CITY OF MOBILE
Lighting for Japanese Gardens and Segment 1 of the Three Mile Creek Greenway Trail
Project No. 2025-2045-01

ADDENDUM 1

This addendum includes the following:

Sheet Number:
C5.00

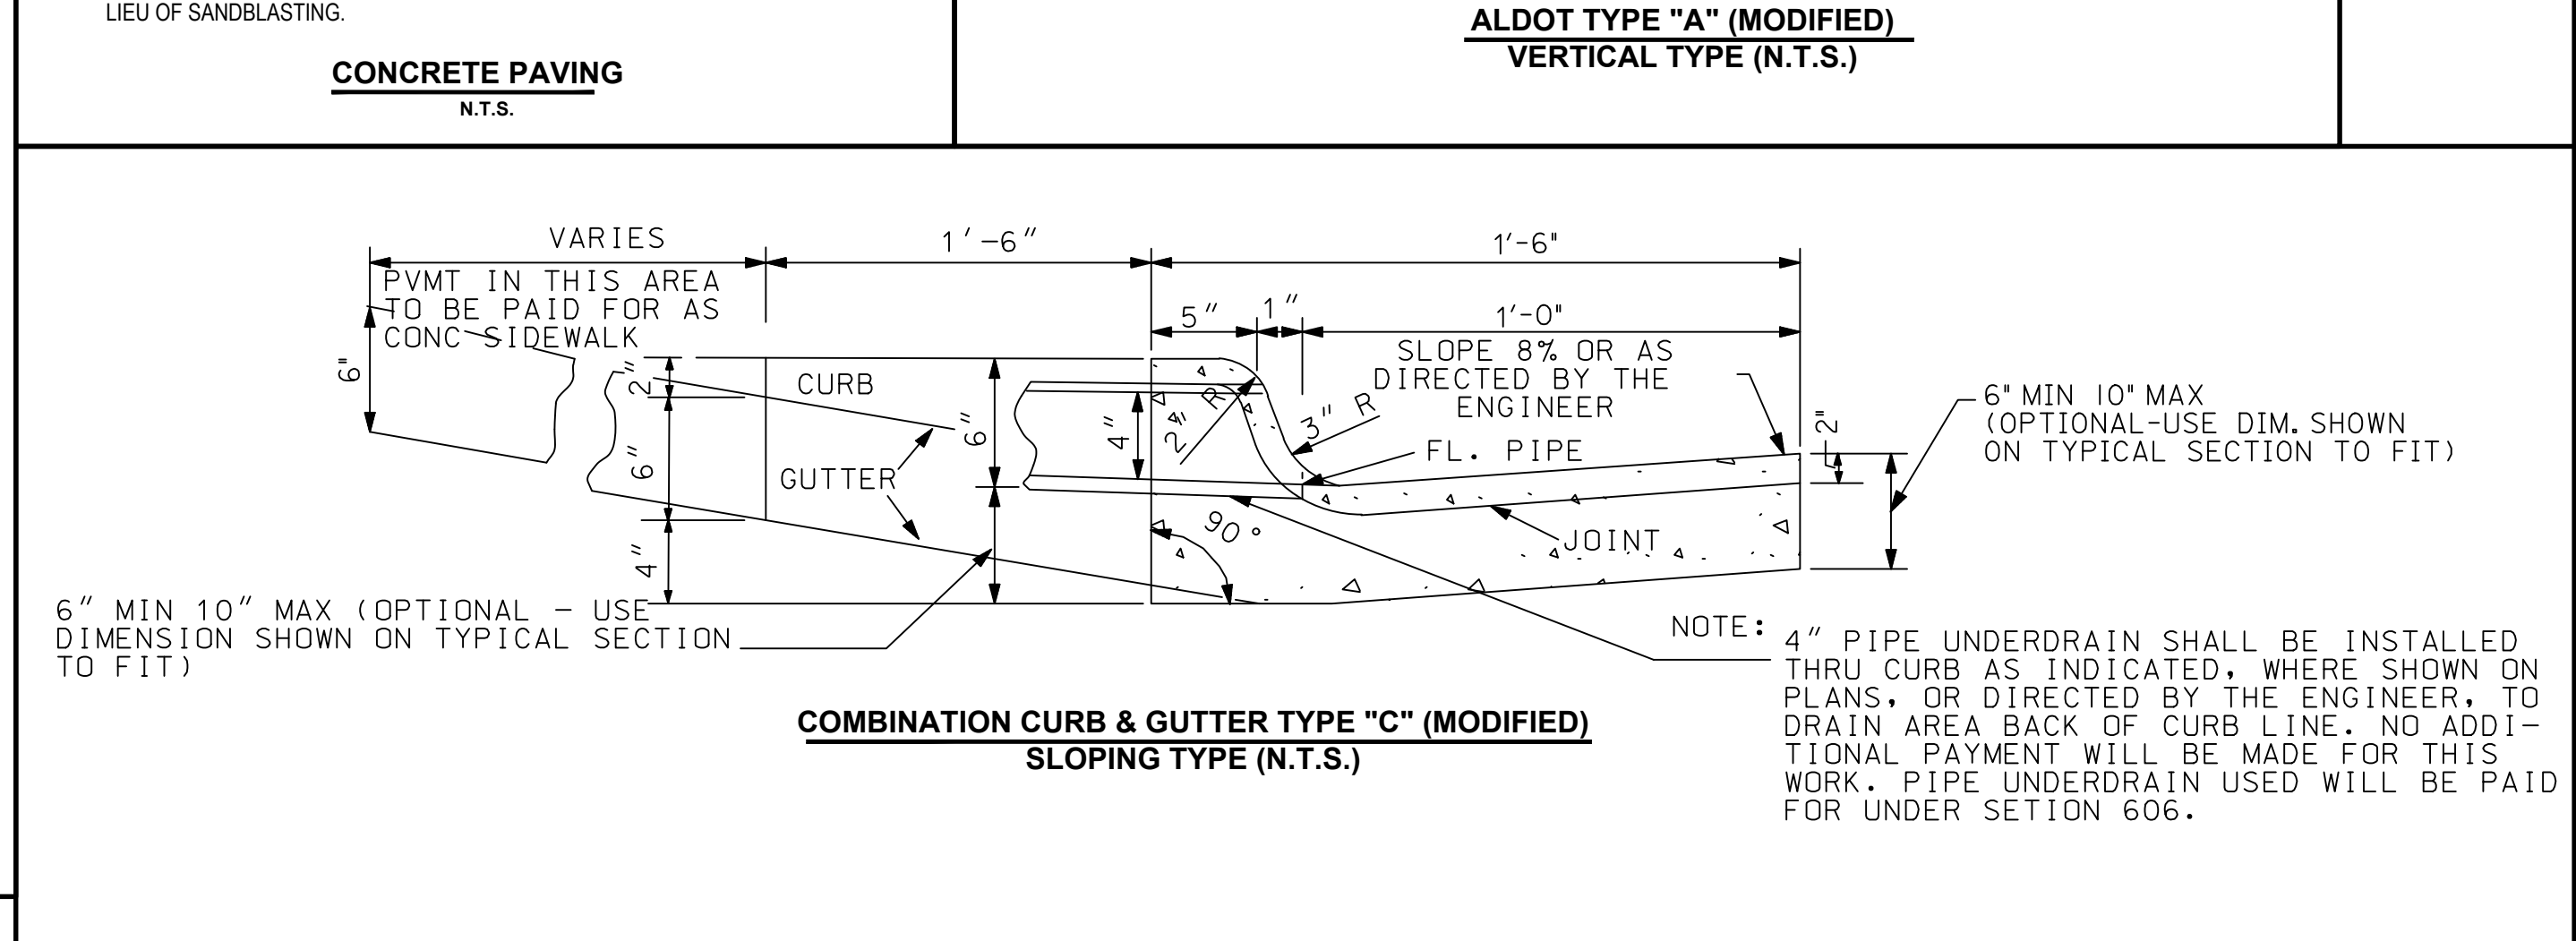
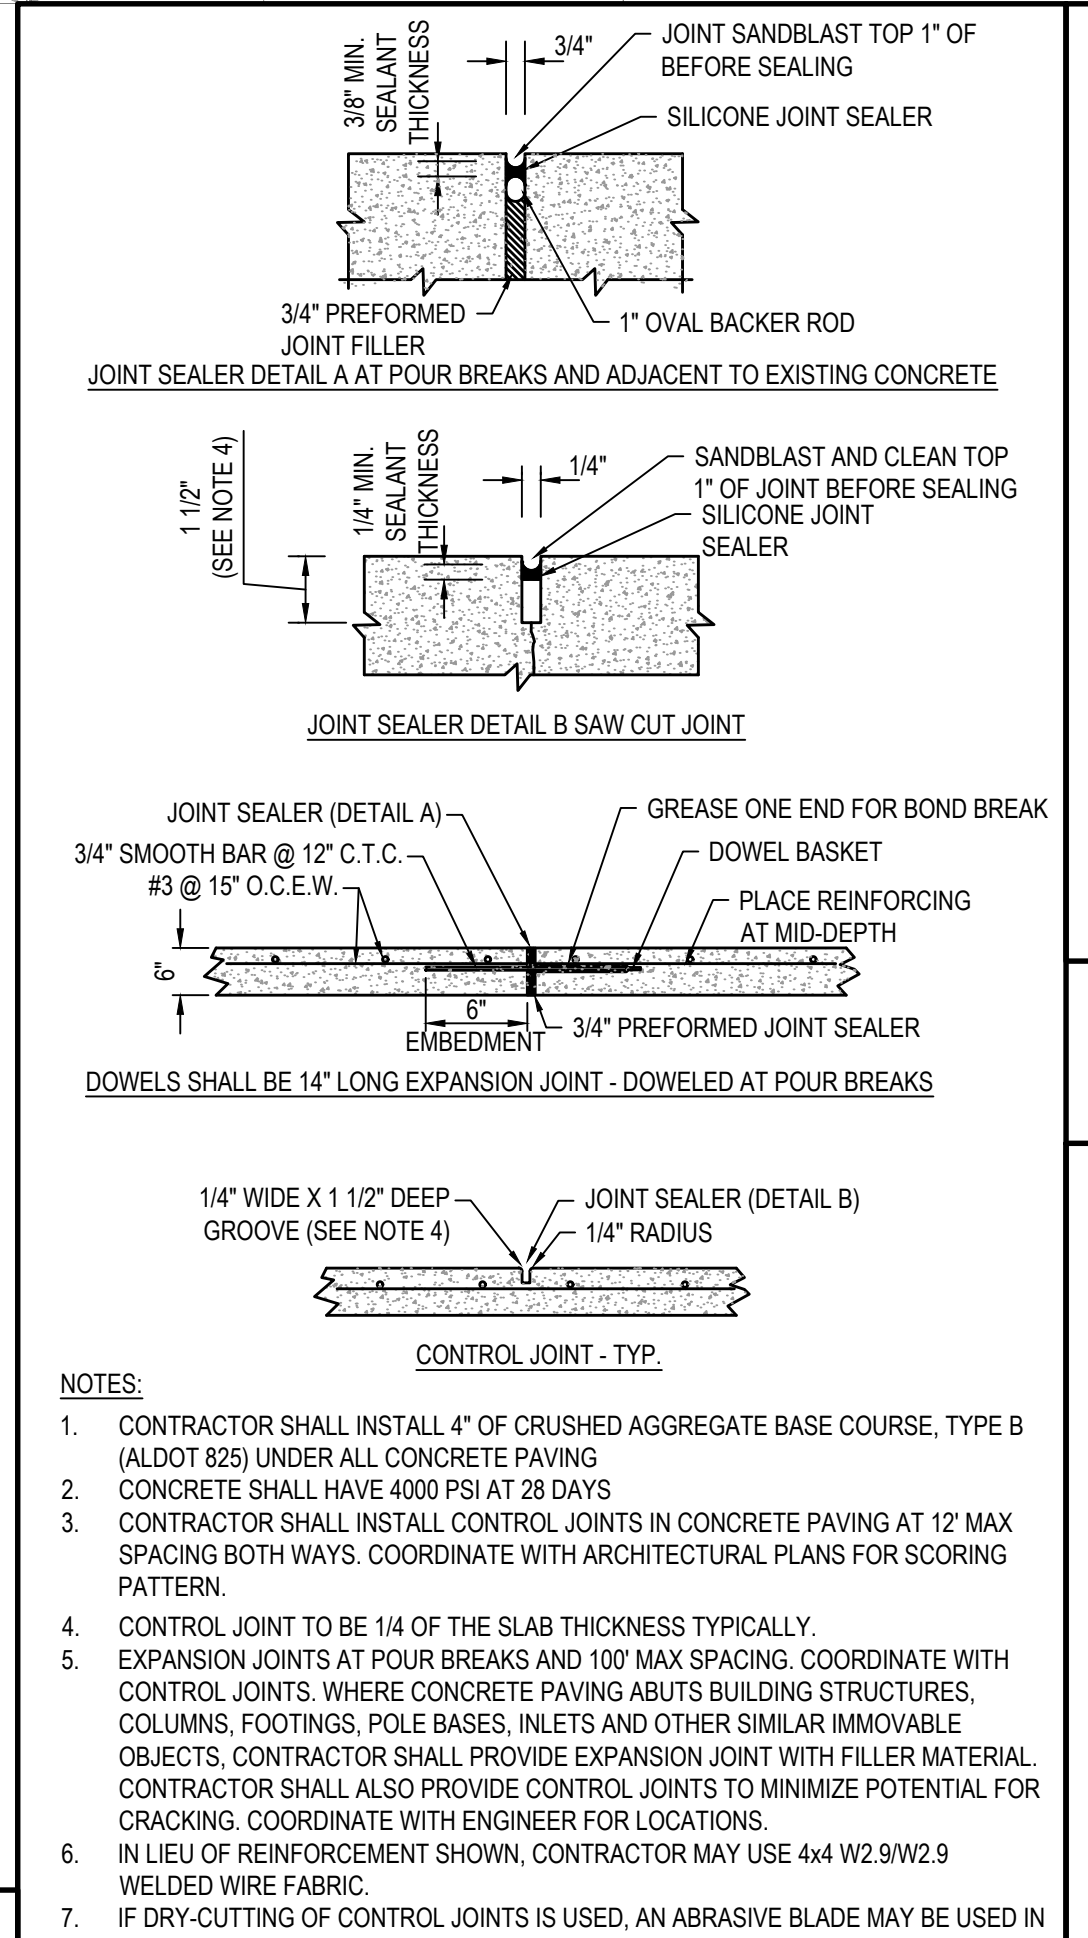
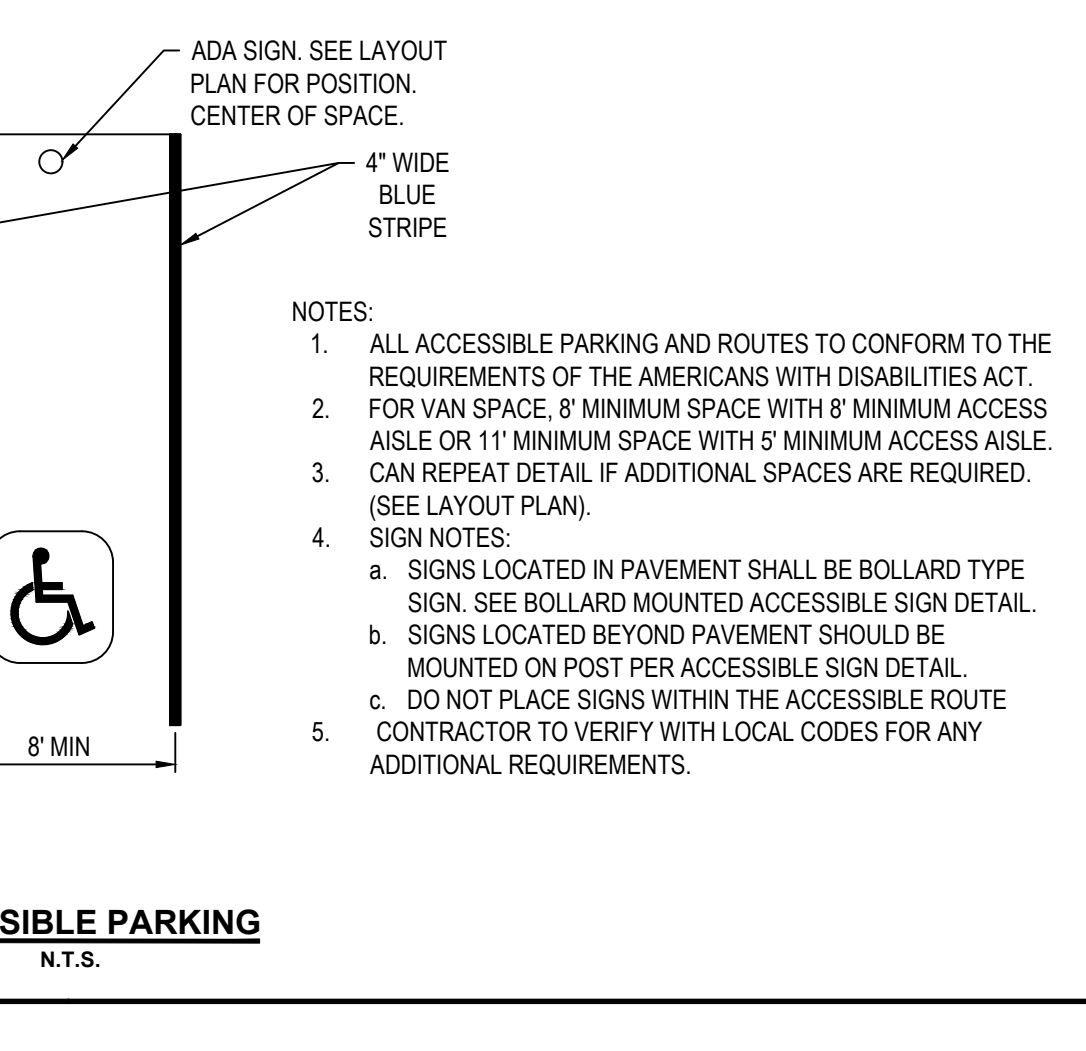
19. Please provide the build-up and typicals for the walking path and ribbon curb along the trail for informational purposes

See Attachment A.
